Durango and Gorman

SUBMITTAL:

1st

CITY OF LAS VEGAS		DATE:
INTER-OFFICE MEMORANDUM		June 25, 2020
TO: Land Development Services Department of Building & Safety		FROM: Jennifer Shinn, P.E. Flood Control, Engr. Associate Department of Public Works
SUBJECT:	Drainage Study for:	COPIES TO:
	Durango and Gowan	Taney Engineering
Cross Streets:	NEC and SEC of Gowan Rd and Durango Dr	Emma Burns
File Number:	F:\Depot\DSMemos\DS5290A.doc	Bart Anderson, P.E., DevCo
Parcel Number:	138-09-201-020; 138-09-301-001	CCRFCD
Zoning Action:		
FEMA Flood Zone	YES NO X	
Proposed Storm Drain	YES NO X

FIGURE 6
DEVELOPED OFFSITE AND ONSITE BASIN MAP

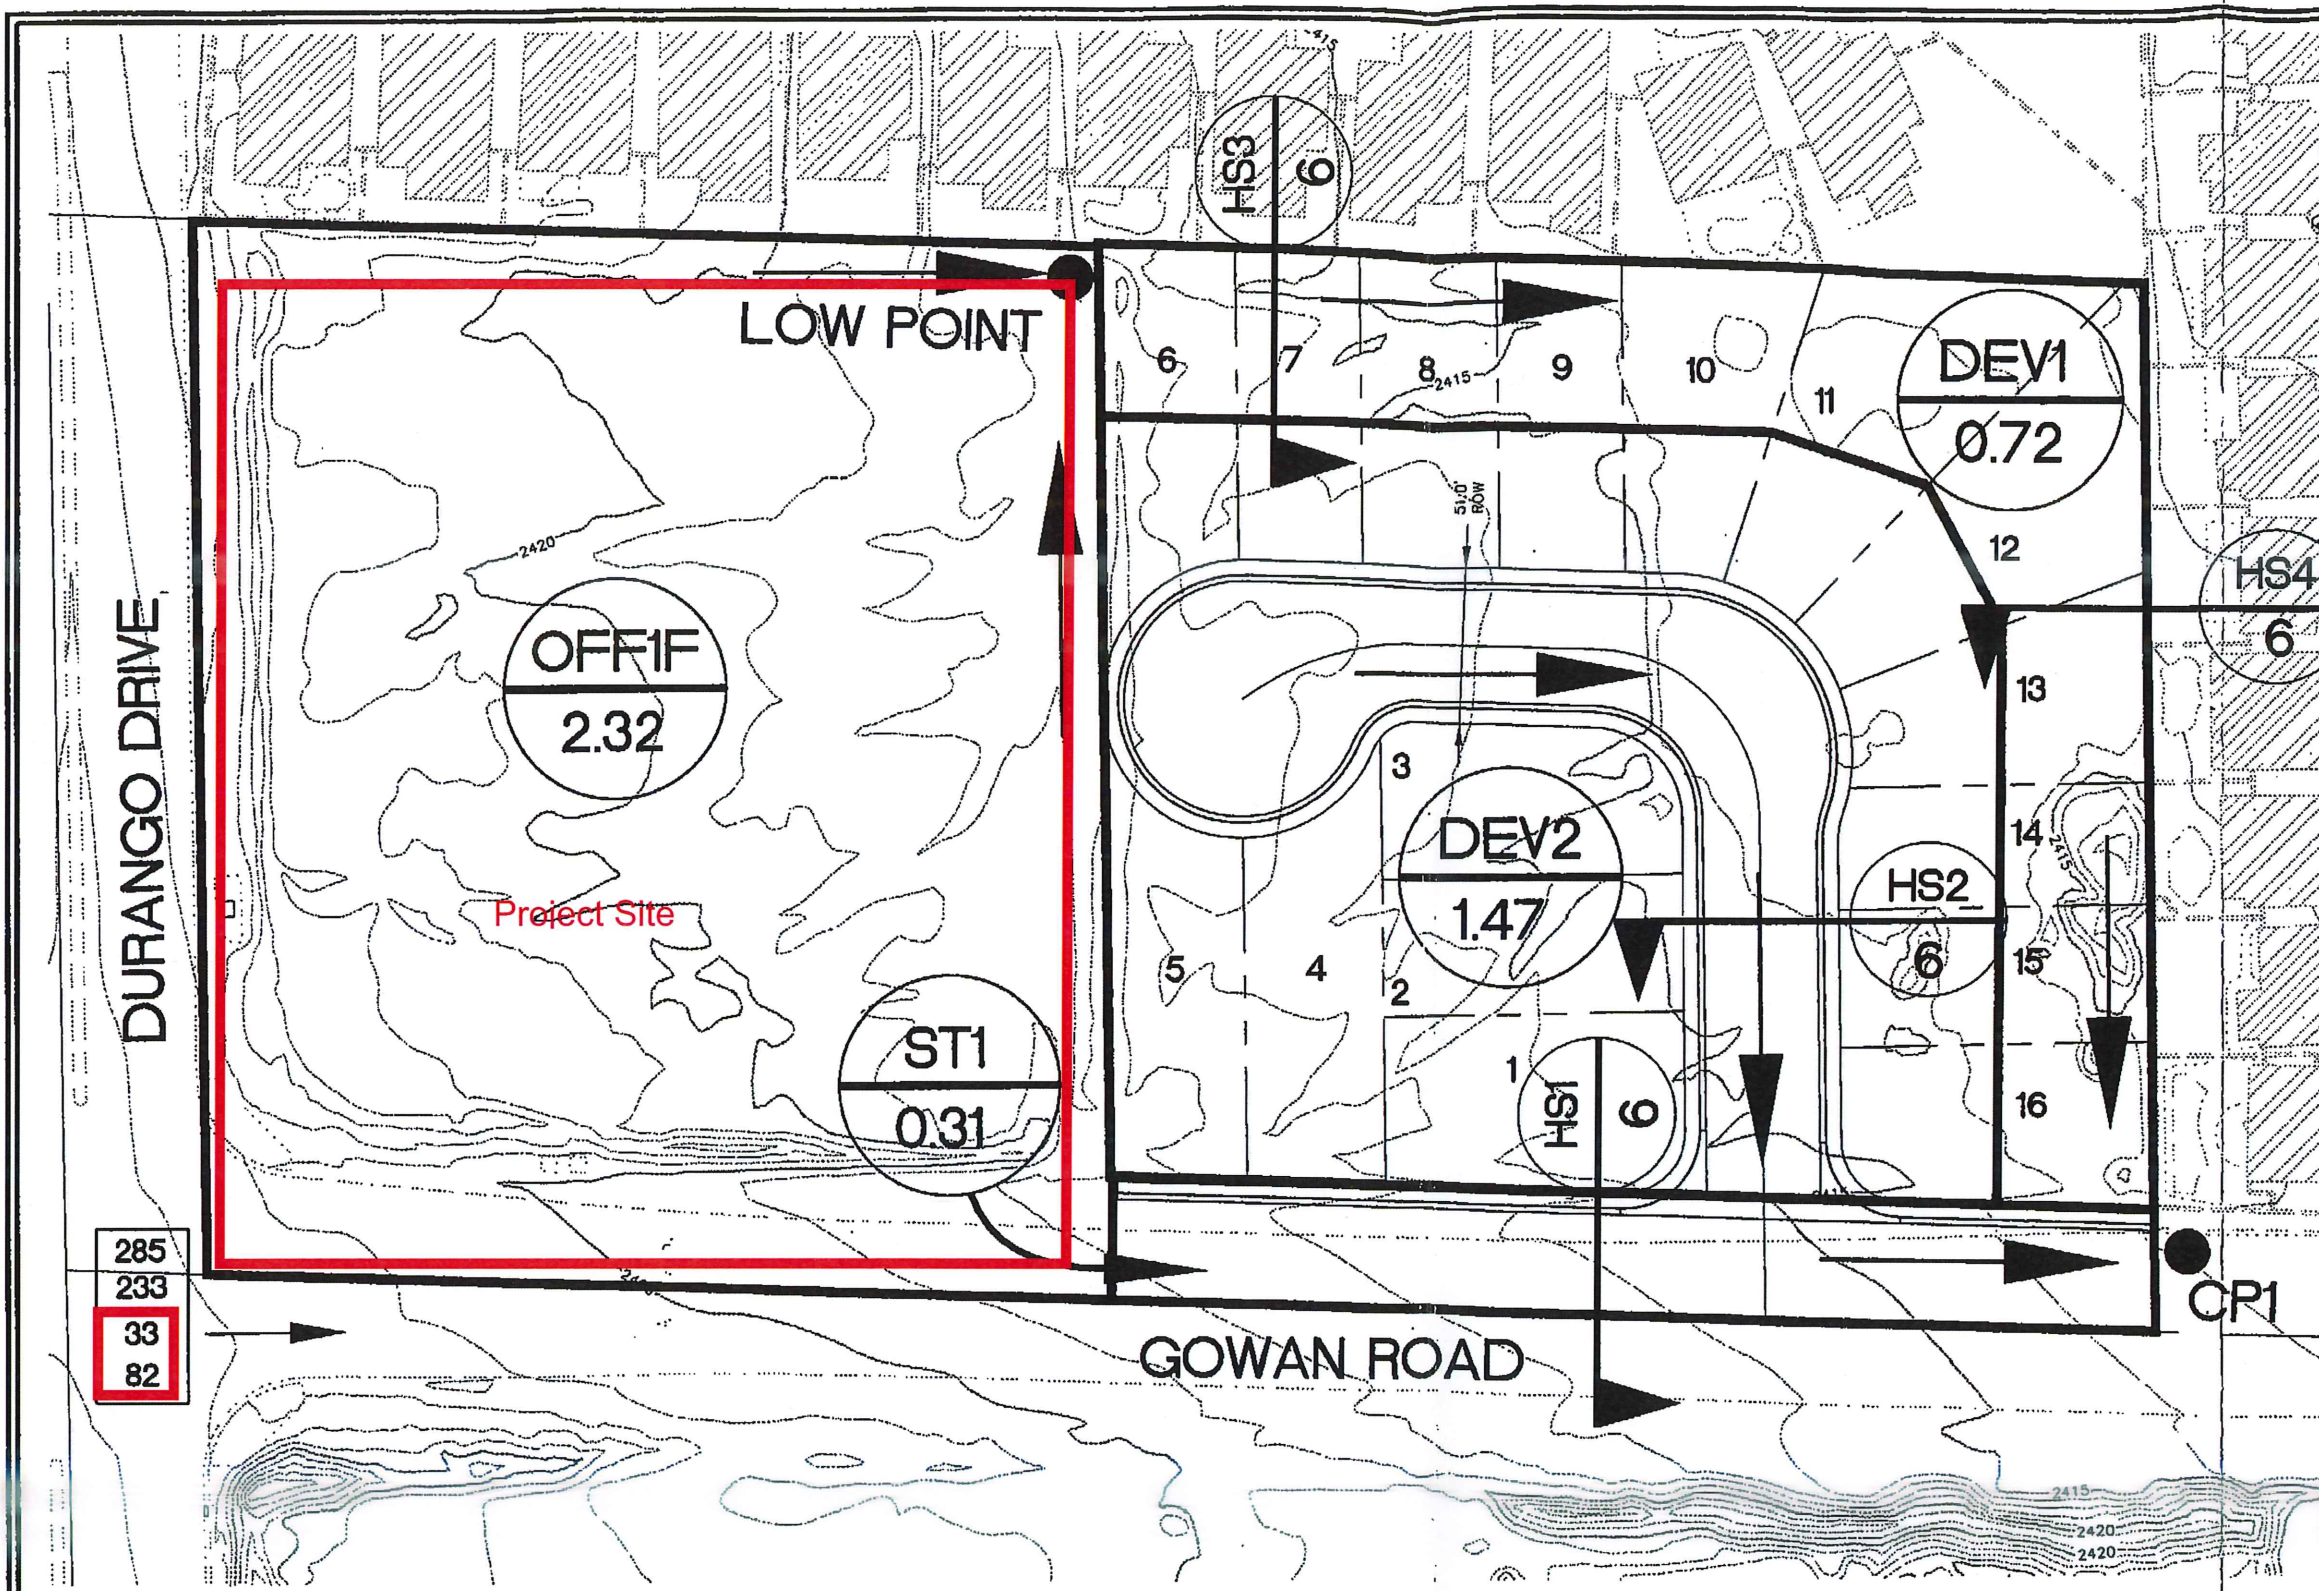
9. Figure 6, Developed Offsite and Onsite Basin Map, contains a table of storm flow rates. The title of the table must be revised to change "Existing" to "Developed" and the third basin listed must be revised from "DEV1" to "DEV2".

14. Recommendation number 7 of the study states that lots 6 through 16 shall be constructed with Type "B" drainage. The onsite developed analysis, Figure 6, also shows Type "B" drainage. The grading plan however shows all lots with Type "A" drainage. The grading plan or developed condition analysis must be revised accordingly.

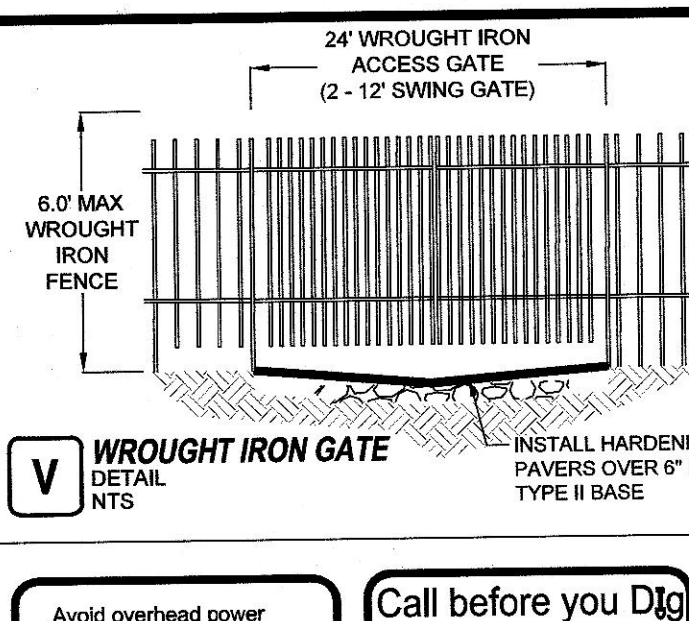
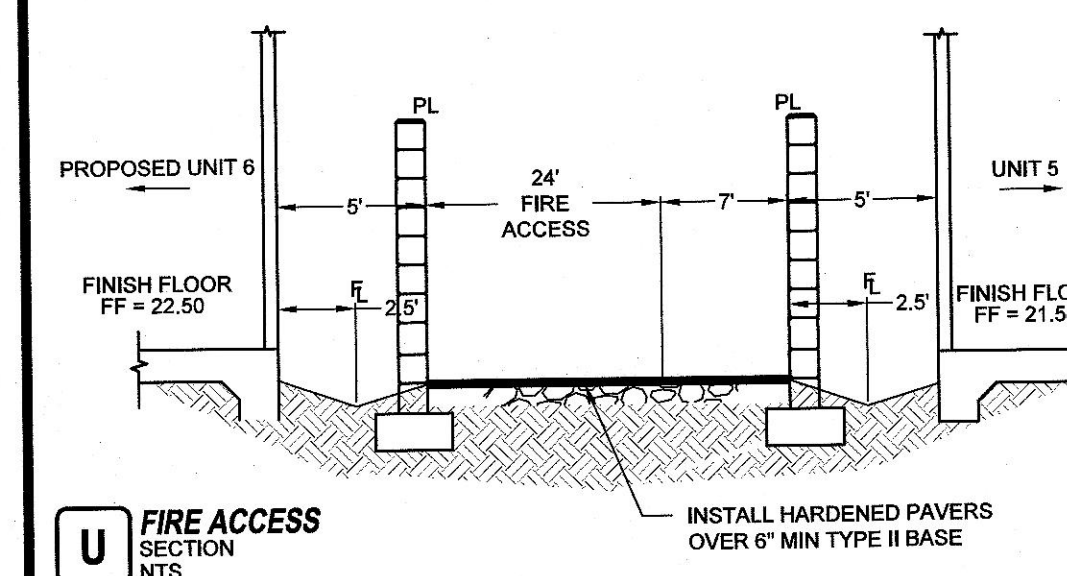
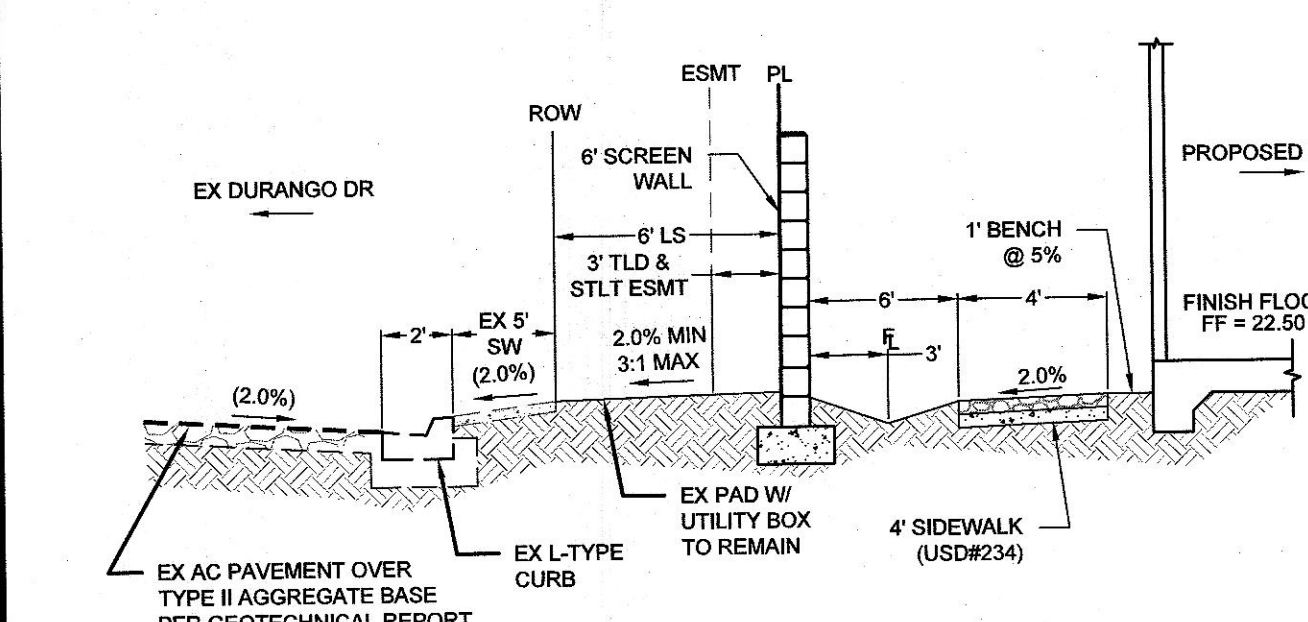
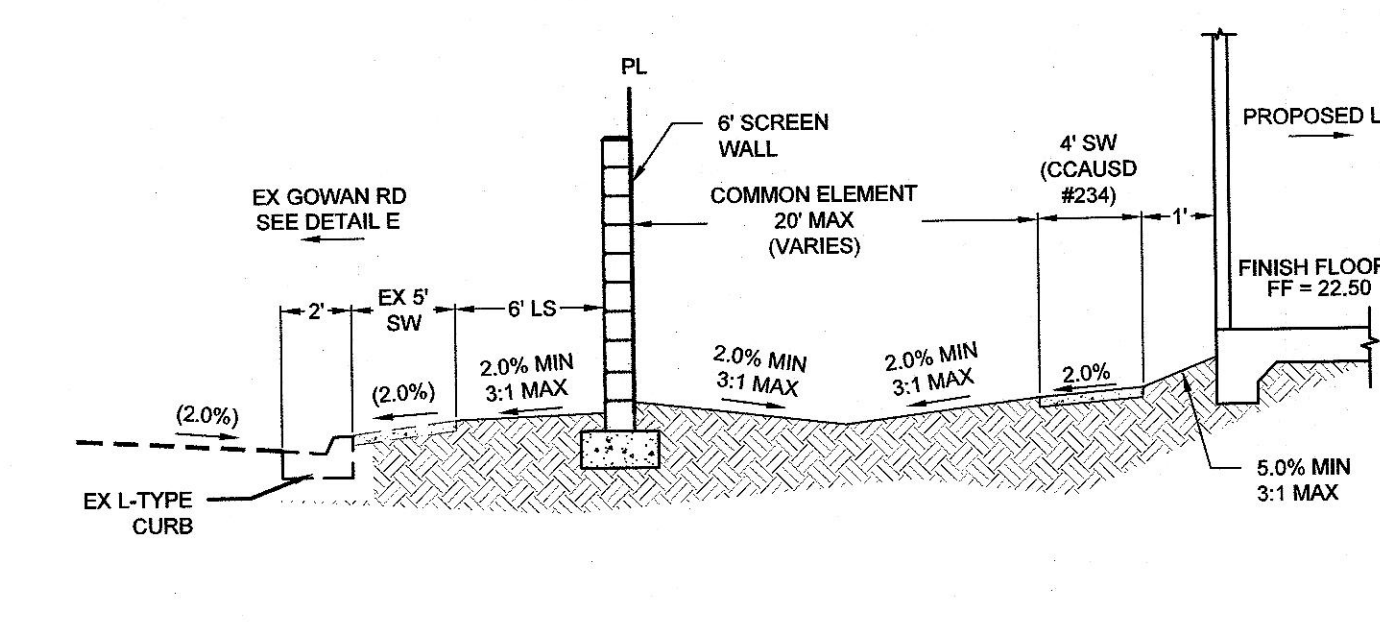
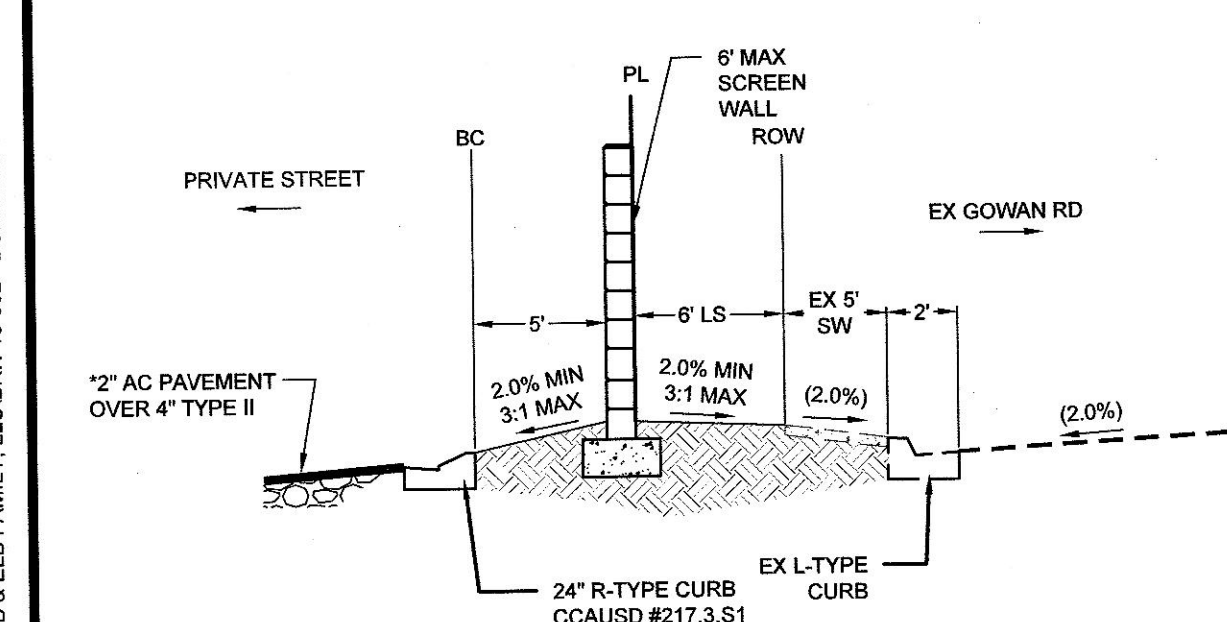
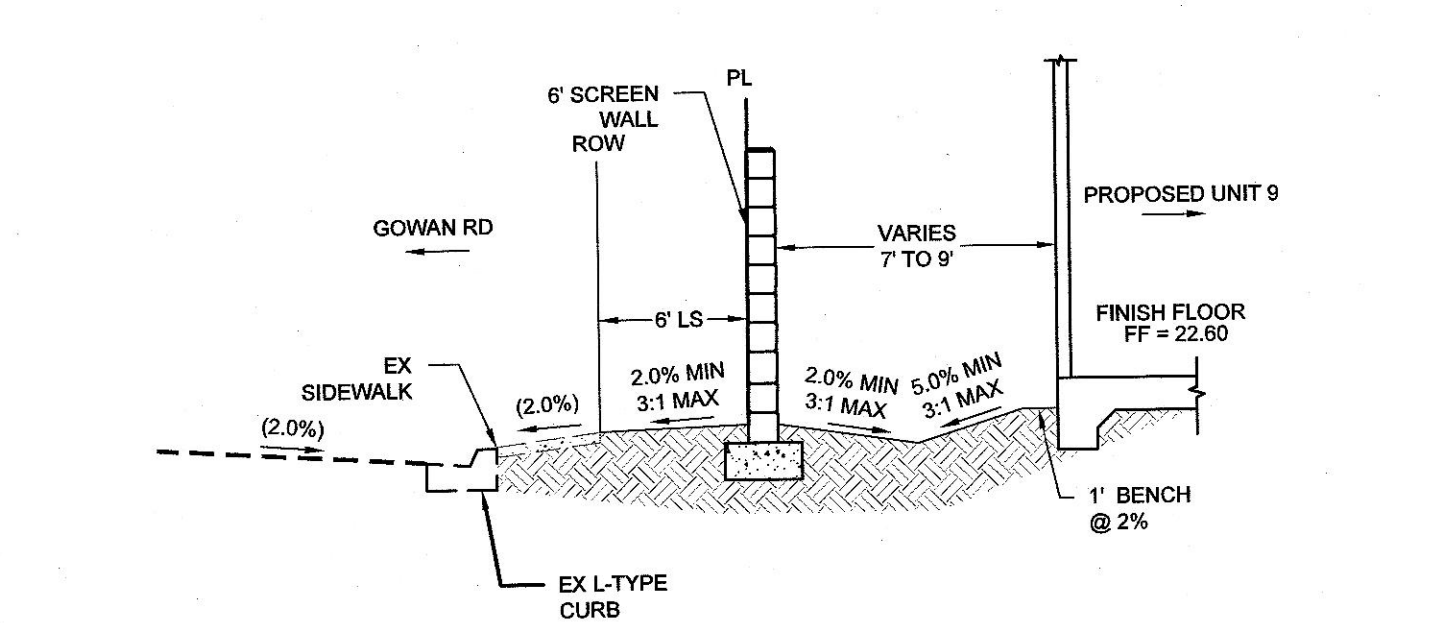
15. Provide a note on the Grading Plans that all onsite storm drain facilities are privately owned and privately maintained by the HOA.
16. Revise Section Detail A on Sheet GD1 to match the Grading Plan.

17. Flip the directional arrow for callout R/GD1 on Sheet G1 to match the Section Detail.
18. Revise Section Detail AA on Sheet GD2 to reflect "Public" Drainage Easement. Delineate and call out the easement on the Grading Plan.

19. Review and revise all Section Details so that the finish floor elevations shown on the details match the Grading Plans.
20. This drainage study assumes that the project will be constructed in one phase. If improvement plans are submitted to break the project into separate phases, a drainage study update will be required for each phase addressing the interim condition.
